UNITED STATES PATENT AND TRADEMARK OFFICE

| APPLICATION NO. | FILING DATE | FIRST NAMED INVENTOR | ATTORNEY DOCKET NO. | CONFIRMATION NO. |
|-----------------|-------------|----------------------|---------------------|------------------|
| 09/899,334 | 07/05/2001 | Johan Ubbi | 1931/62303 | 2617 |

Office Action Summary

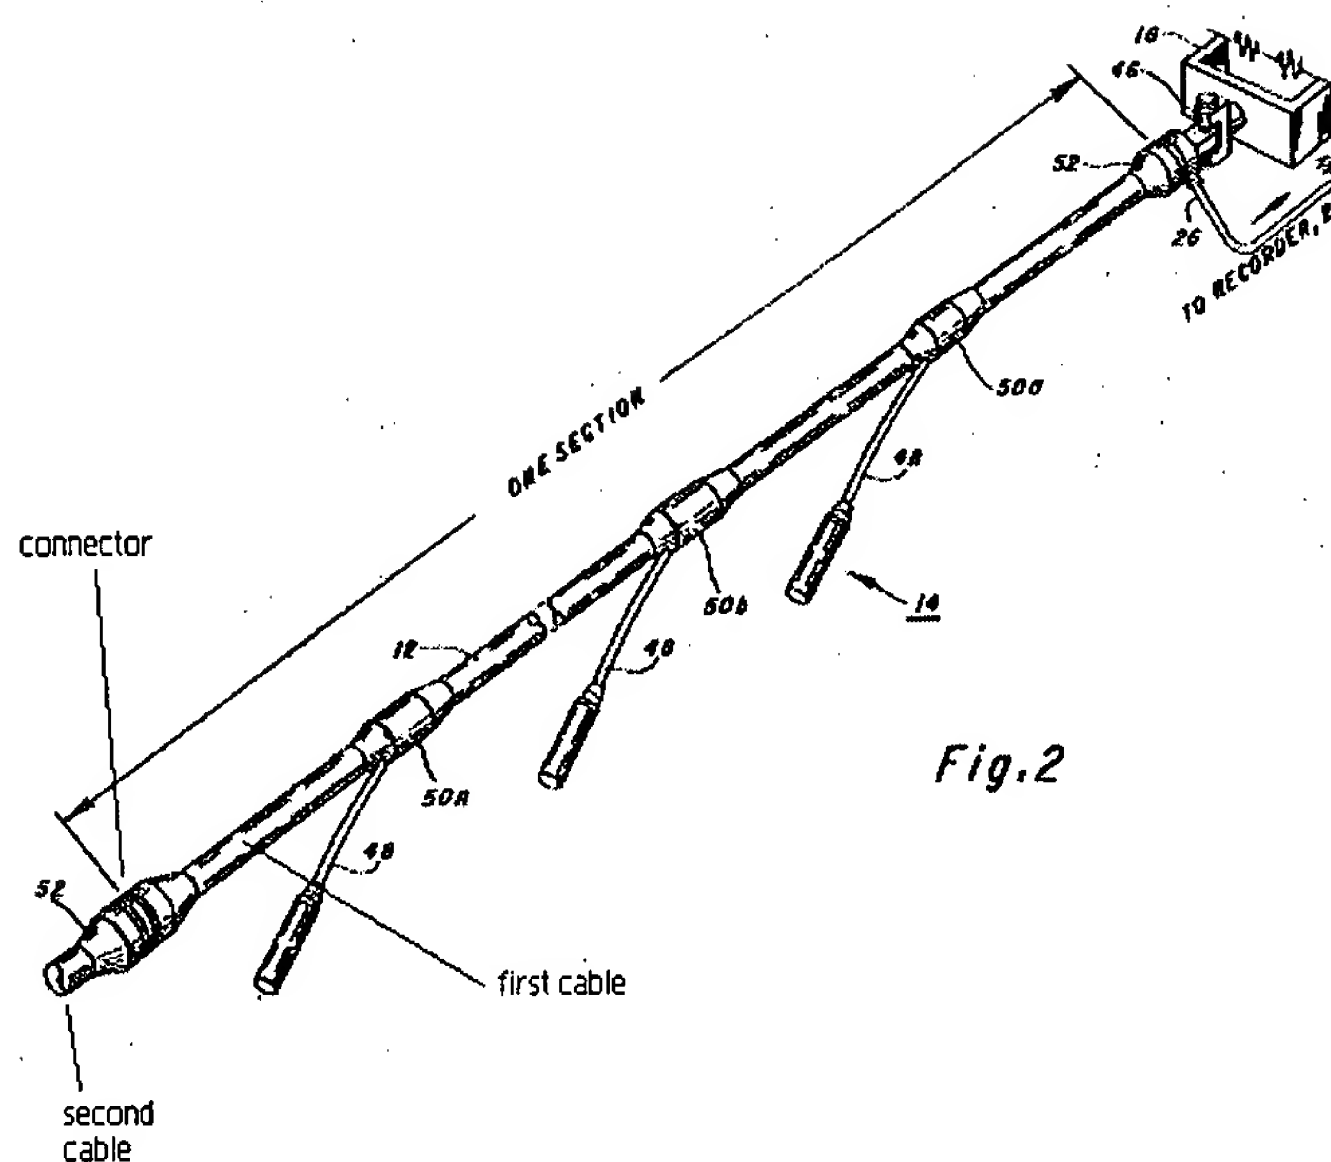
In response to applicant's arguments that Kruppenbach does not show "a monitoring cable for connection to a monitoring equipment and a plurality of respective cables, each of the plurality of respective cables including a plurality of individual wires each extending substantially an entire length of the respective cable, each of the plurality of individual wires of each of the plurality of cables having an end terminating at the connector", it is first noted that a recitation of the intended use of the claimed invention (e.g. for connection to a monitoring equipment) must result in a structural difference between the claimed invention and the prior art in order to patentably distinguish the claimed invention from the prior art. If the prior art structure is capable of performing the intended use, then it meets the claim. See *In re Casey*, 152 USPQ 235 (CCPA 1967) and *In re Otto*, 136 USPQ 458, 459 (CCPA 1963). Additionally, see the following figure.

In this case, the connector (52) is capable of being connected to a monitoring equipment, and each of the plurality of individual wires of each of the plurality of cables (first cable and second cable) have an end terminating at the connector (52).
